**Re: Ridgeview Addition– Drainage Study in support of the Preliminary Plat - First Review**

Halff Associates, Inc. was requested by the City of Sanger to provide a review of the drainage study and downstream assessment in support of the preliminary plat for the Ridgeview Addition development. The drainage study prepared Allison Engineering Group was received on November 21, 2022.

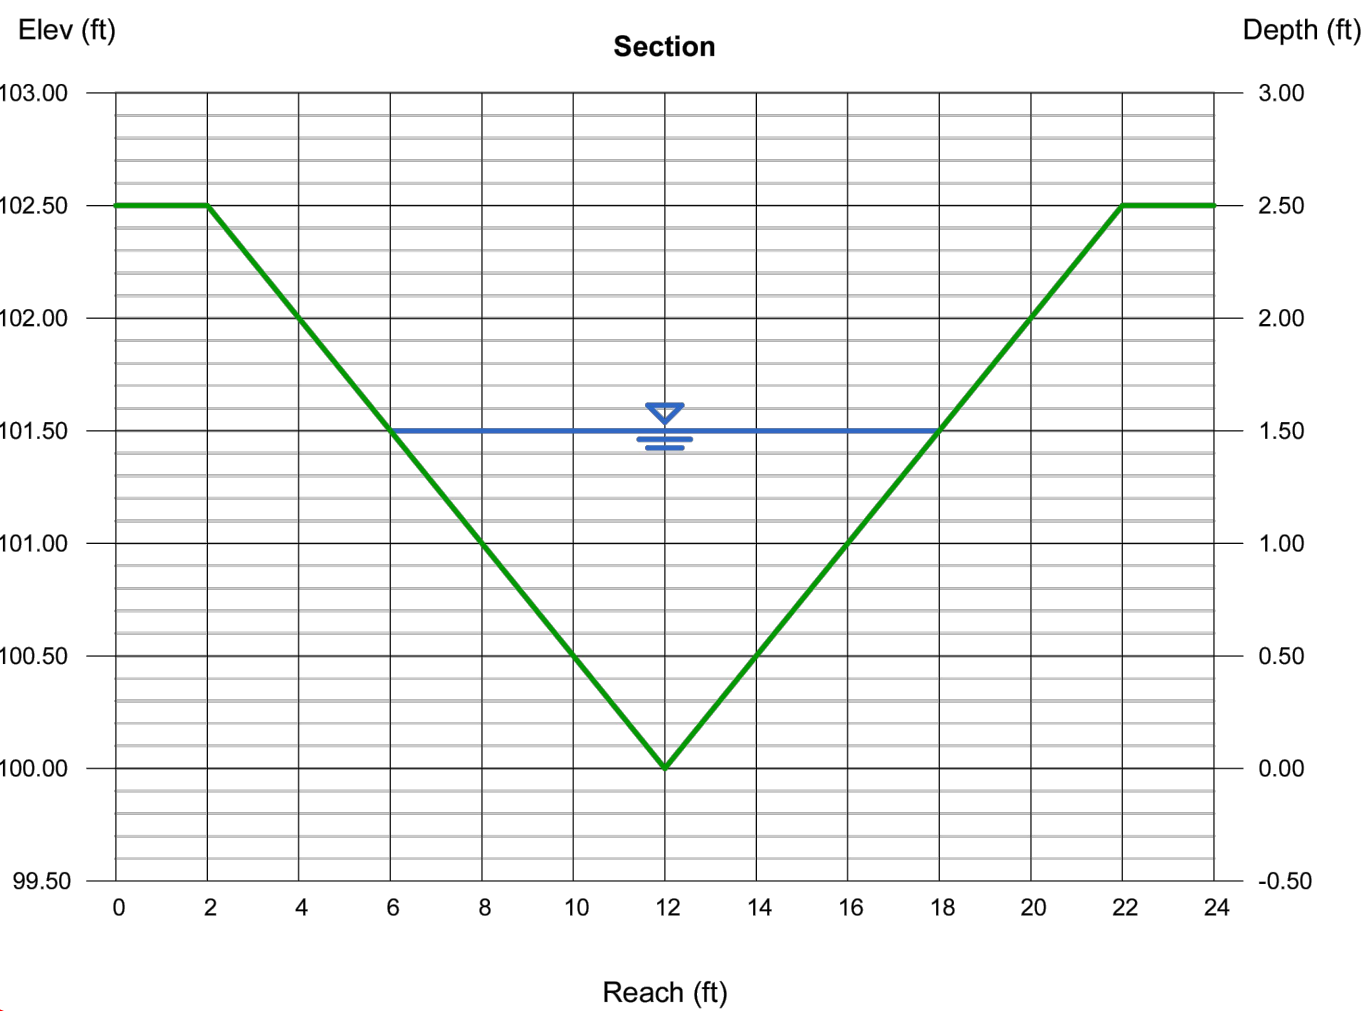
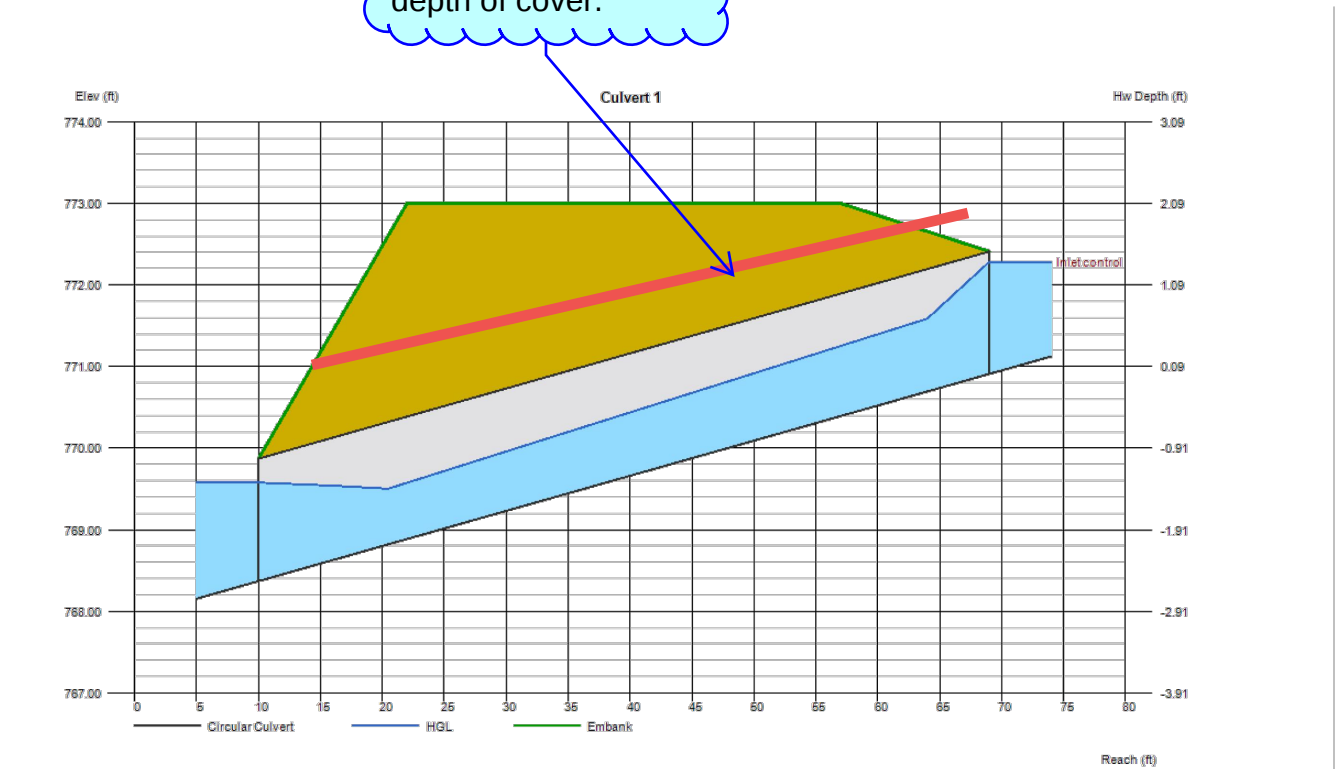
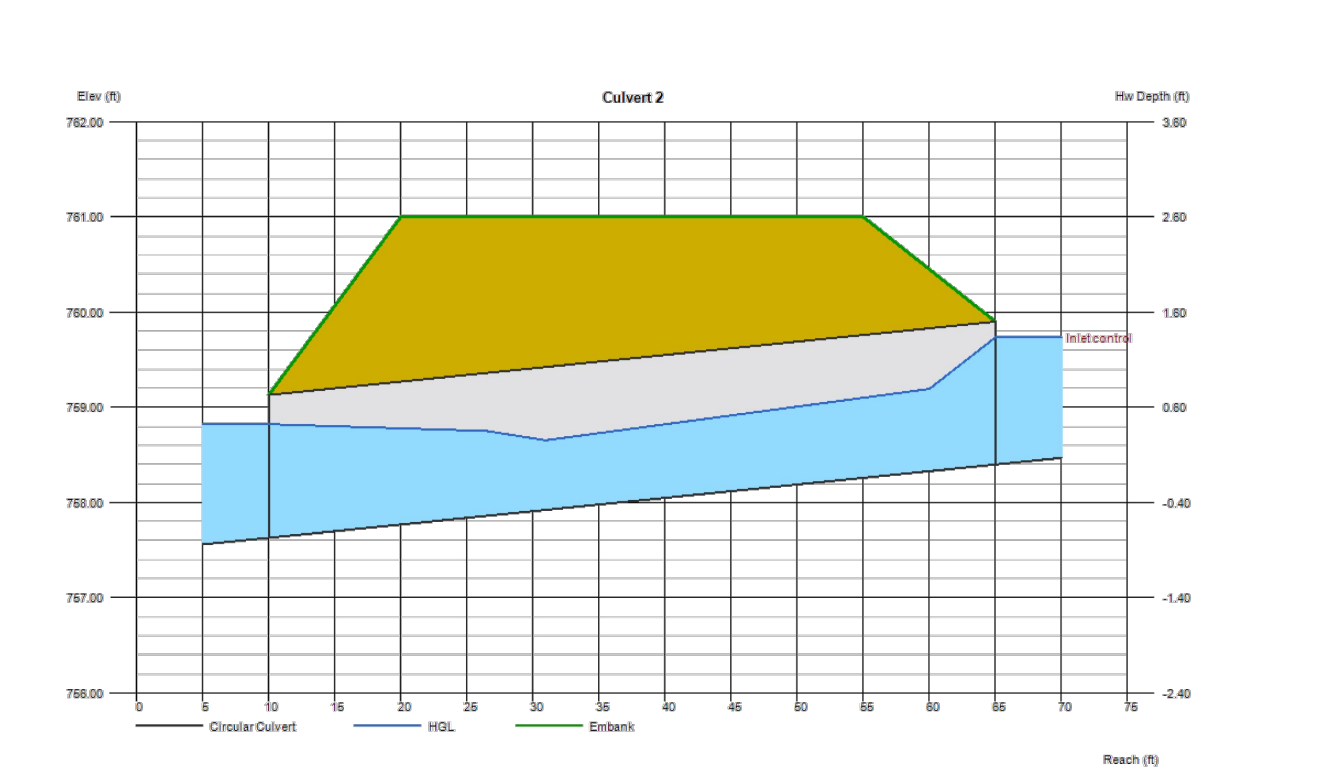
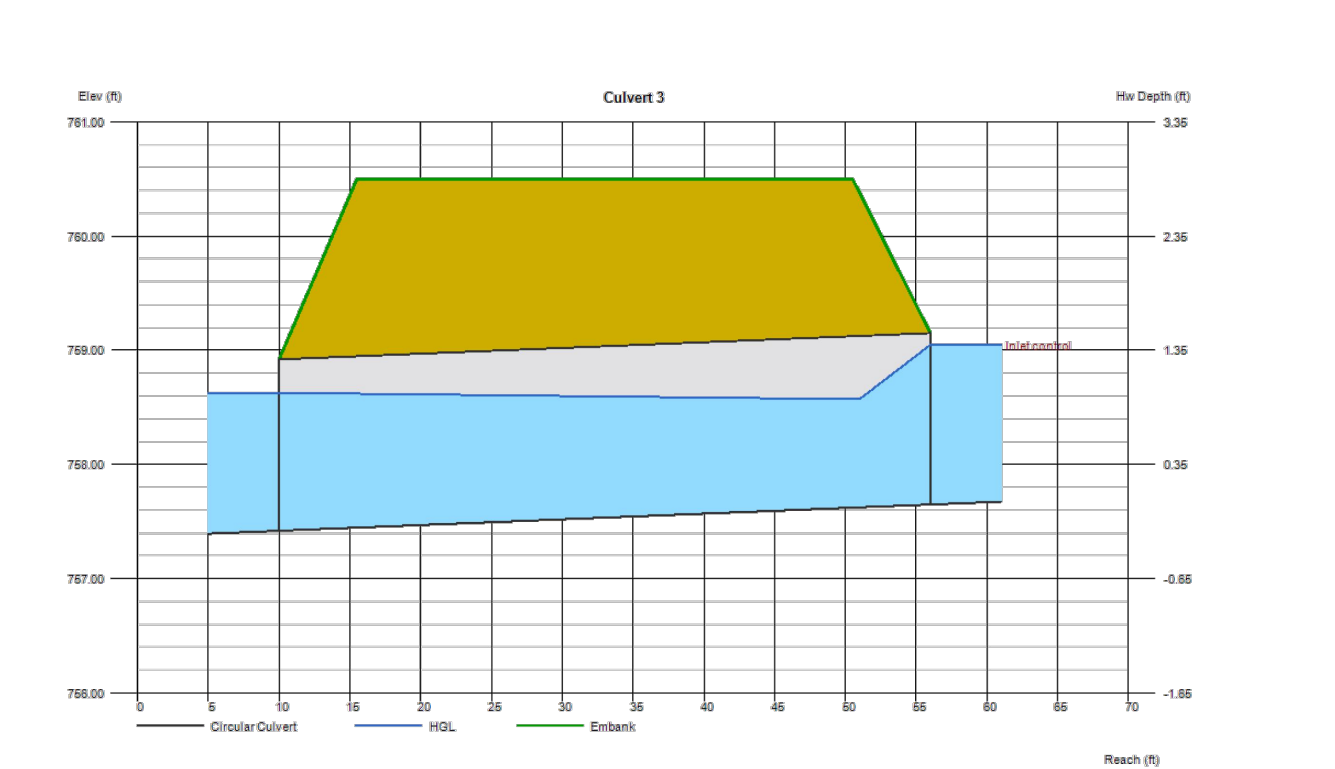
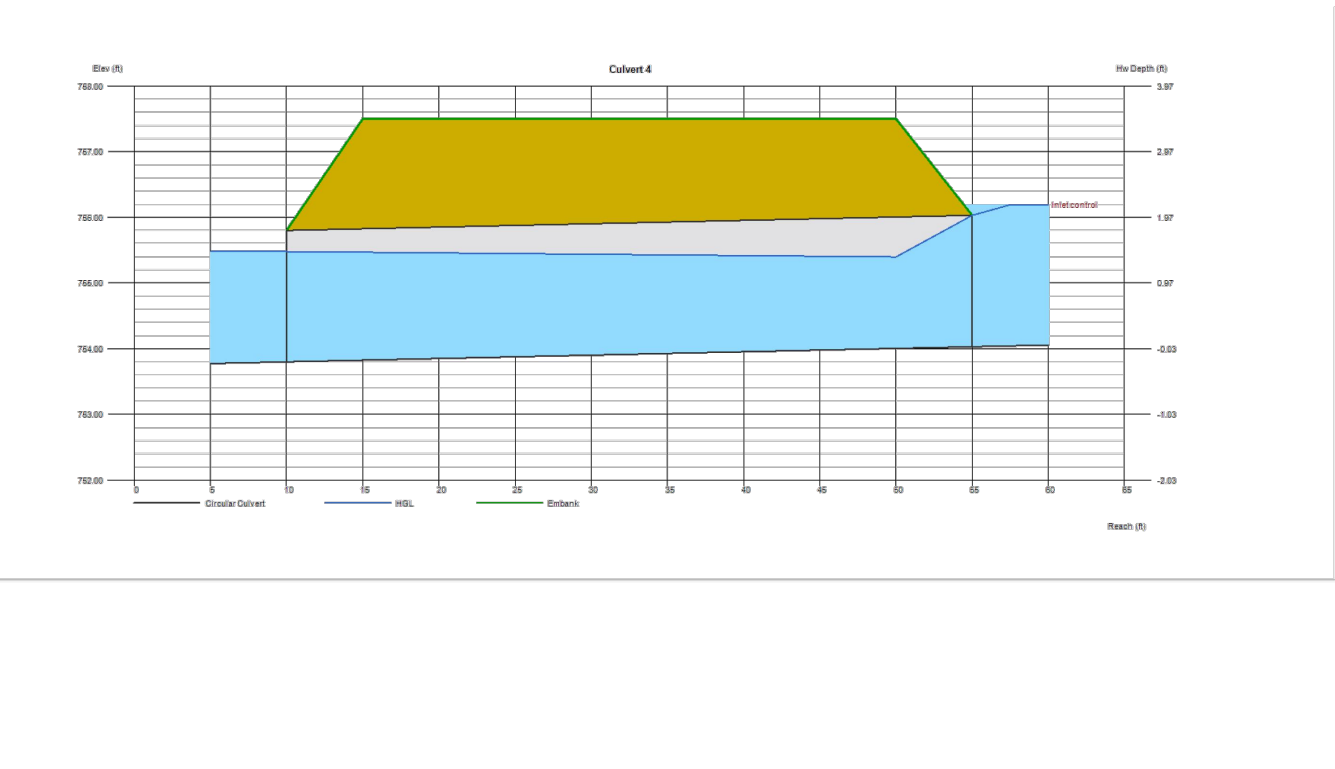
Provide RAS model for all proposed roadside ditches (Criteria Manual Section IV.3.4). Include proposed culverts and driveway culverts and verify the 100-yr fully developed flow is contained within the right of way. If not contained within ROW, additional DE must be dedicated to contain the fully developed 100-yr water surface elevation. This comment can be addressed with Final Drainage Study.

Provide culvert plan and profiles for all cross drainage structures. Make there is enough depth of cover.

OVERALL GRADING PLAN

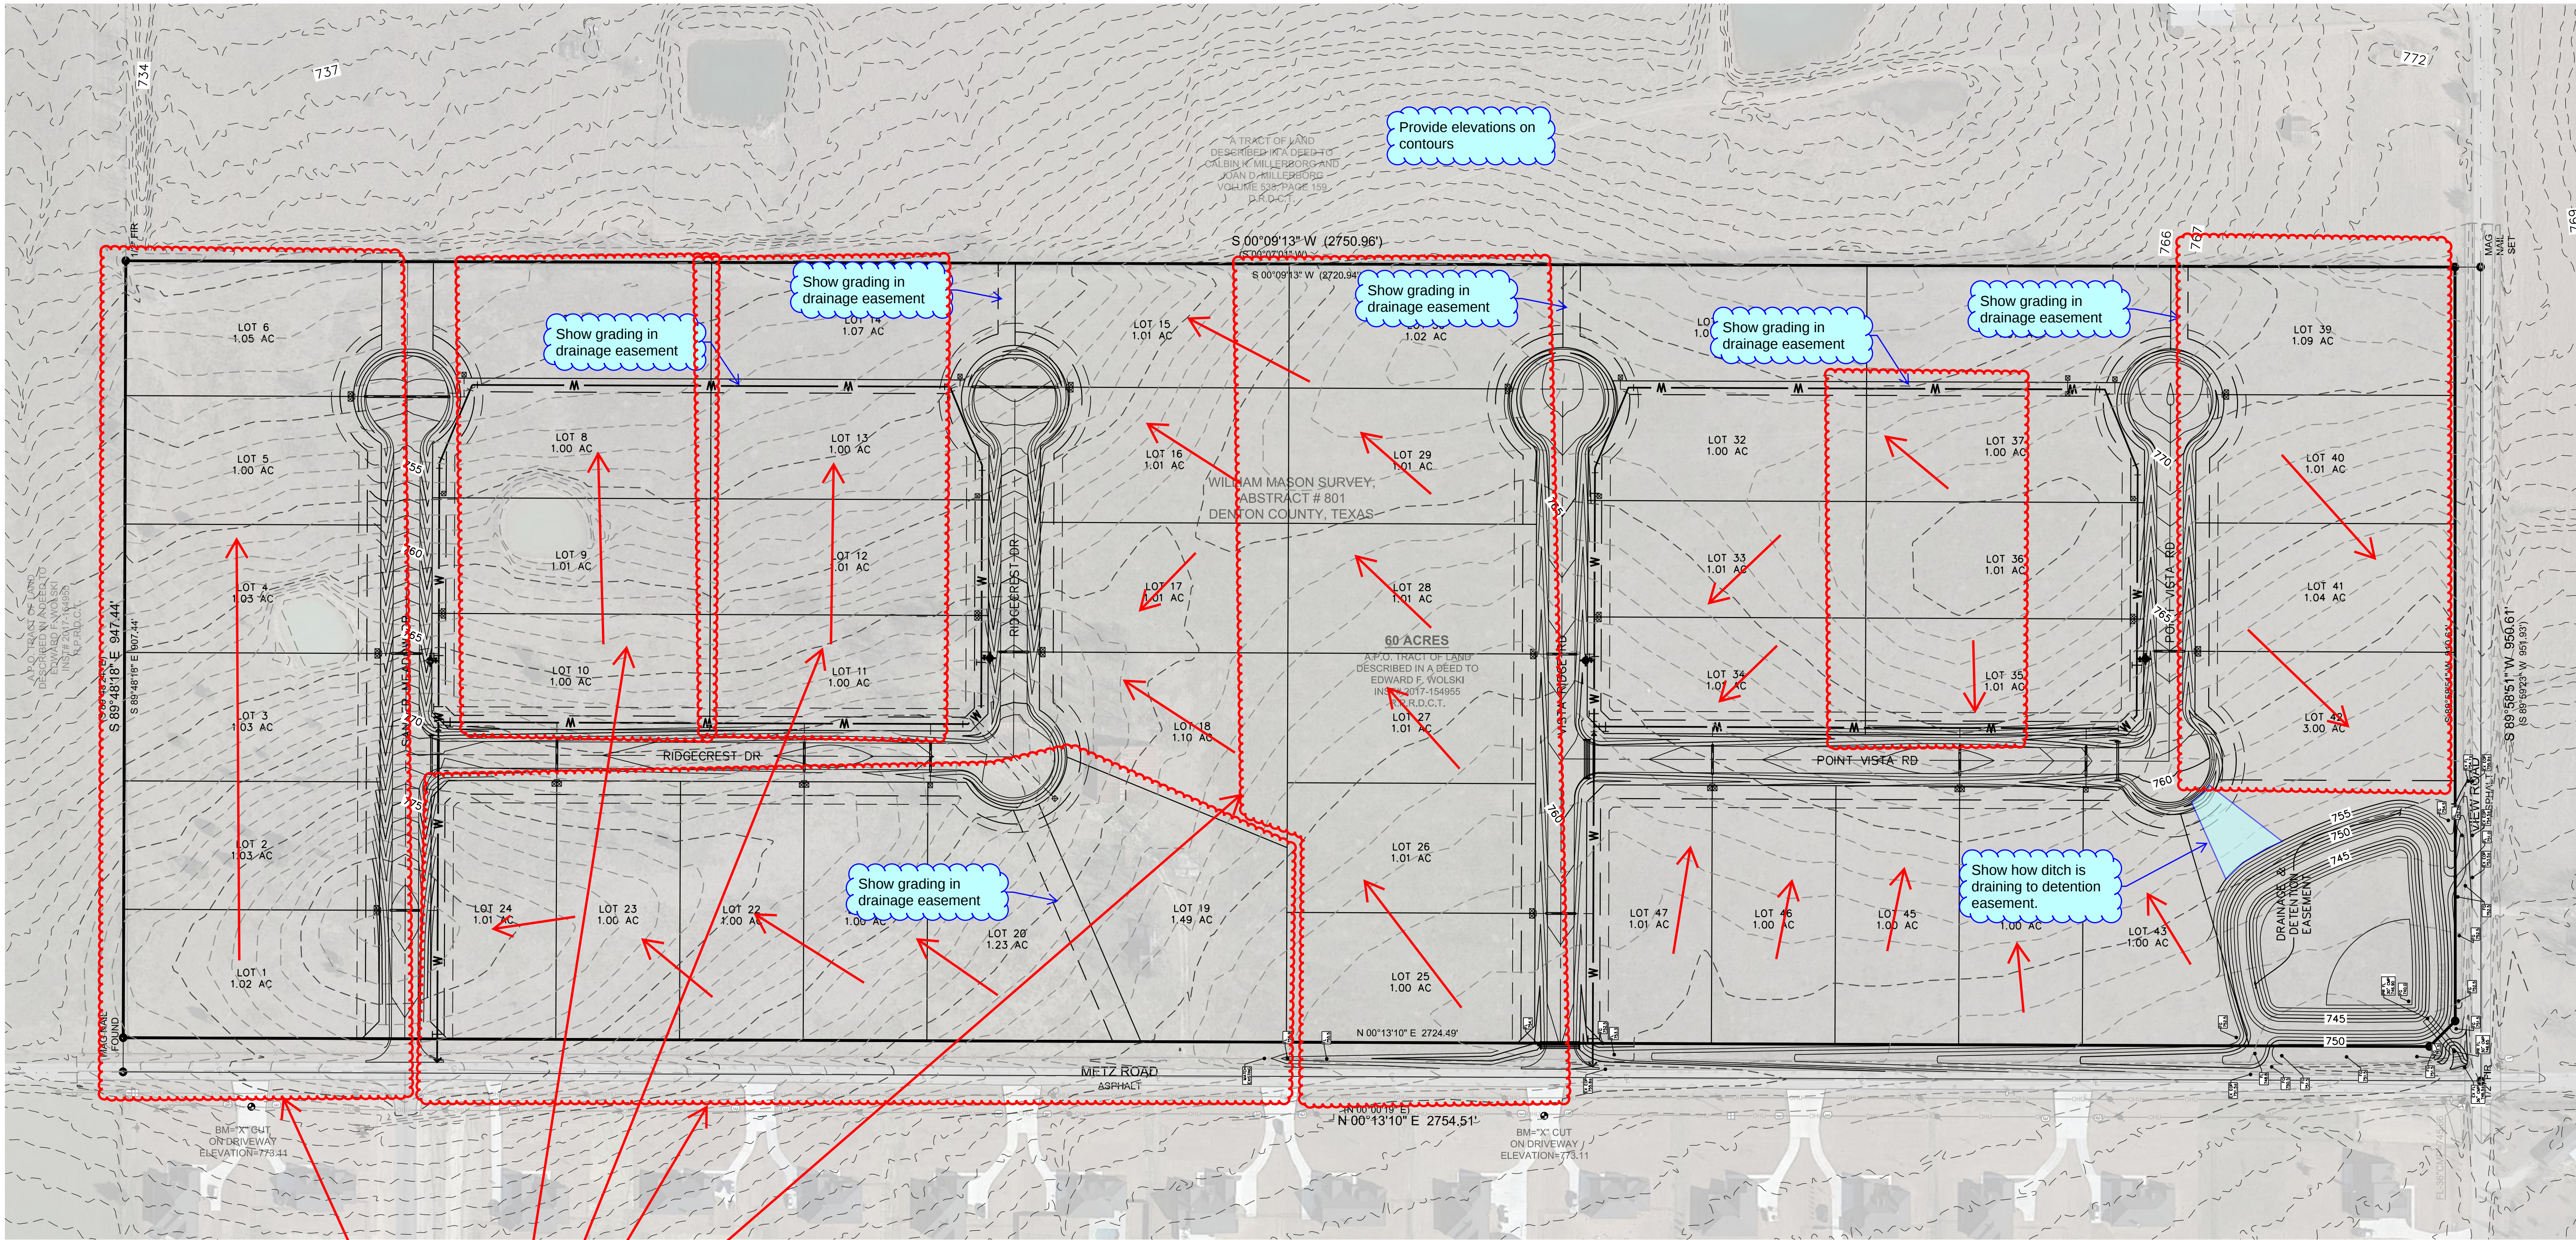
1. Please add flow arrows onsite and offsite to show drainage patterns.
2. Label contours (at least the index contours).3
3. Please show proposed storm drain lines and shade back.
4. Please add flow arrows along proposed road side ditches.

Per the City variance, lot to lot drainage is only allowed across two lots before being picked up in a drainage easement. Provide side yard swales as needed to direct lot flows to the roads. Some instances have been identified. Please check for all.
